Subdivision Authority

File No. LDA08-0141

RE: Tentative plan of subdivision to create 149 single-detached residential lots, 36 semi-detached residential lots, 1 multi-family residential lot, 2 municipal reserve lots, 1 environmental reserve lot and 2 public utility lots from a portion of SE-19-53-25-4, located north of Yellowhead Trail and west of 199 Street; **BIG LAKE NEIGHBOURHOOD ONE**

I The Subdivision by Plan is APPROVED on August 28, 2008, subject to the following conditions:

SUBDIVISION CONDITIONS OF APPROVAL MAP

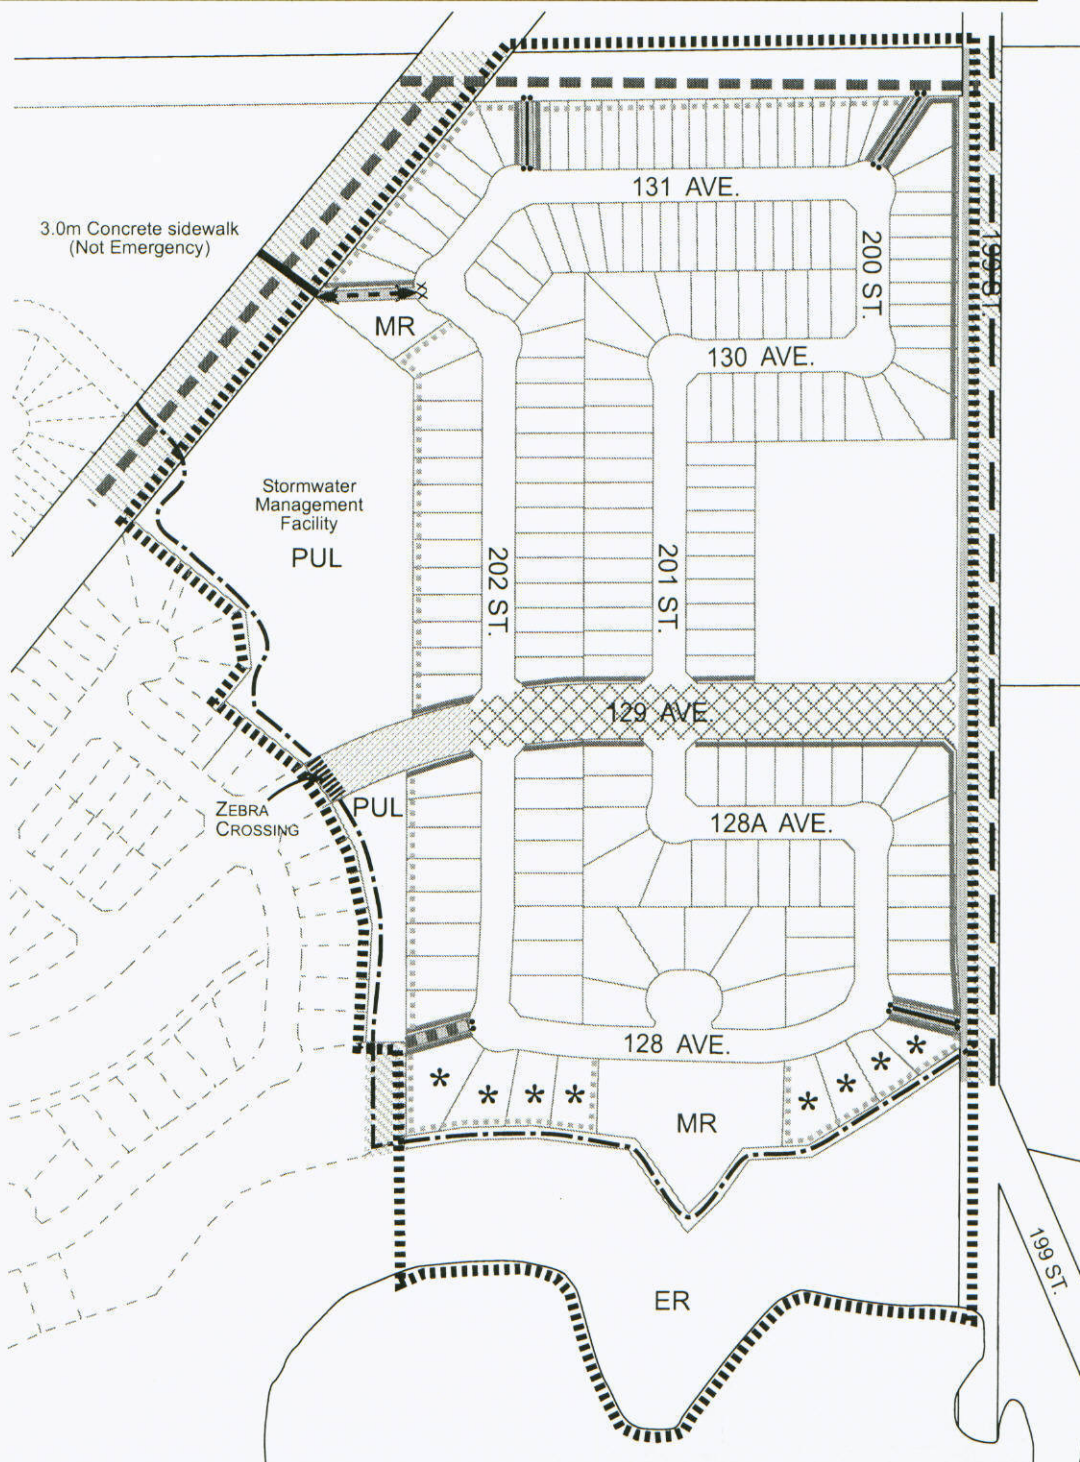
1. that the owner dedicate Municipal Reserve as a 0.11 ha parcel and a 0.49 ha parcel pursuant to Section 666 of the Municipal Government Act as shown on the "Conditions of Approval" map, Enclosure I;

3. that the owner dedicate Environmental Reserve as a 2.40 ha parcel pursuant to Section 664 of the Municipal Government Act as shown on the "Conditions of Approval" map, Enclosure I;

4. that the owner enter into a Servicing Agreement with the City of Edmonton pursuant to Section 655 of the Municipal Government Act;
5. the owner dedicate 1.94 m of road right-of-way on the west side of the existing 199 Street, as shown on Enclosure I;

6. that the owner dedicate and register as road right-of-way a 6 m emergency access walkway, as shown on Enclosure I;
7. that the owner prepare the necessary plans and documentation to grant new or carry forward existing easements and restrictive covenants in favour of the City of Edmonton, EPCOR Distribution Inc., EPCOR Water Services Inc. and ATCO Gas, as required by the aforementioned agencies or shown on the engineering drawings that are deemed to be part of the Servicing Agreement;

8. that the owner prepare a restrictive covenant in favour of the City of Edmonton that will be placed on all lots backing onto the top-of-bank line as per the applicable development restrictions shown by the CT & Associates Engineering Inc. geotechnical report and City recommendations (File No. LDA08-0141), as shown on Enclosure I; and

10. that the owner upgrade 199 Street to a 14.5 m urban collector roadway standard (24.0 m road right-of-way) adjacent to this subdivision, as shown on Enclosure I. Should the owner/applicant be unable to secure an easement on the east side of 199 Street required to upgrade the collector in its entirety, the Transportation Department would support the deferral of the boulevard and sidewalk construction on the east side of the 199 Street to the development of the land on the east side of 199 Street;

12. that the owner construct a 3 m asphalt multi-use trail with a dividing yellow centerline and "Shared Use" signage within the power line right-of-way northwest of this subdivision and within the sewer pipeline right-of-way at the north end of this subdivision, as shown on Enclosure I;

13. that the owner construct a 2 m granular trail within the public utility lot (PUL) and top-of-bank walkway, as shown on Enclosure I. The owner must extend the 2 m granular trail outside the boundary of the subdivision to connect the west end of the top-of-bank trail to the south end of the trail within the PUL in order to provide a continuous connection for trail users, as shown on Enclosure I;

14. that the owner install a zebra-marked crosswalk with curb ramps and signage at the mid-block trail crossing location along the east-west collector roadway (129 Avenue), as shown on Enclosure I;

15. that the walkways in the north section of the subdivision as well as the walkway in the southeast section of the subdivision contain a 1.5 m concrete sidewalk with bollards, lighting, and 1.8 m uniform fencing to be provided within residential property lines, as shown on Enclosure I. The sidewalks in the northern walkways are to extend to tie into the multi-use trail within the Sewer Pipeline right-of-way;

17. that the emergency access walkway contain a 3 m concrete sidewalk with T-bollards, lighting and 1.8 m uniform fencing to be provided within the residential property line to the north, as shown on Enclosure I;

19. that the owner construct all fences positioned wholly on privately-owned lands to the satisfaction of the Transportation and Asset Management and Public Works Departments in the locations shown on the "Conditions of Approval" map, Enclosure I.
